## Crankcase modifications - ROTAX 582 DCDI

As of engine serial no. 4.084.219 a new crankcase (part no. 886 466) was introduced, replacing the former one (886 221).

### The illustration shows the situation after modification

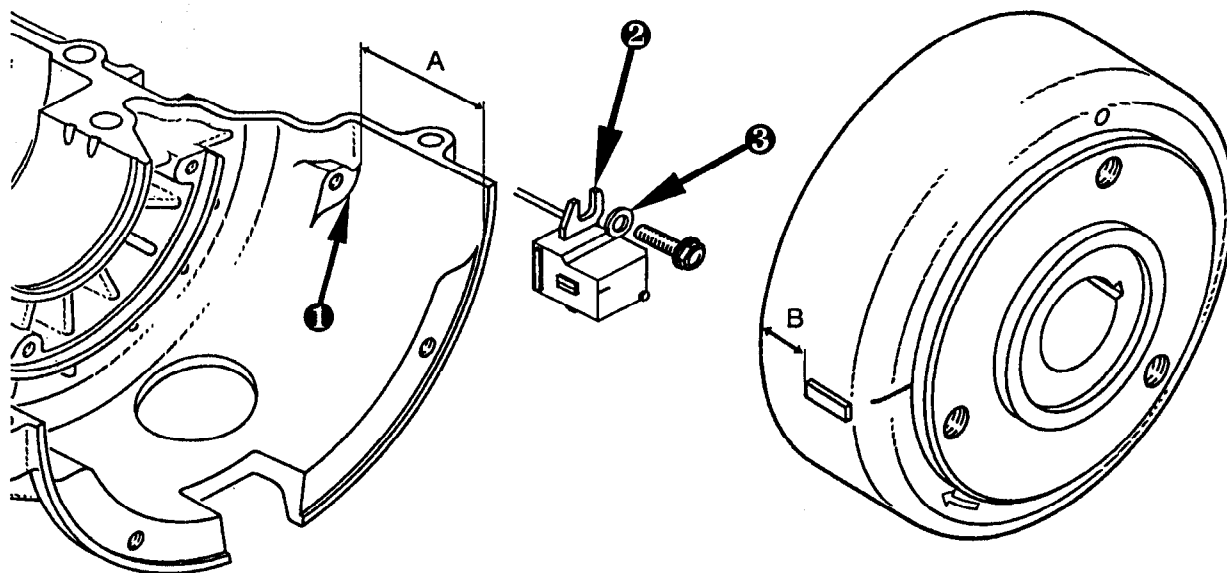
In the new crankcase the dimension „A“ for pick up support ❶ was modified from 30 mm to 55,8 mm. Due to this modification the new pick-ups (965 760 and 965 767), introduced with engine no. 4.017.191, can be fitted and adjusted easier.

The new modified U-shaped fixation brackets ❷ require 4 shims ❸ (827 800).

Due to the new pick-up position, the position of the trigger boss „B“ on magneto flywheel has been modified from 17 mm to 14,5 mm.

As a consequence, a new magneto generator P12W 150 (part no.996 832) was introduced as replacement for part no. 996 830, as of engine no. 4.084.219.

The magneto flywheel (part no. 996 820) was replaced by the new magneto flywheel (996 821).
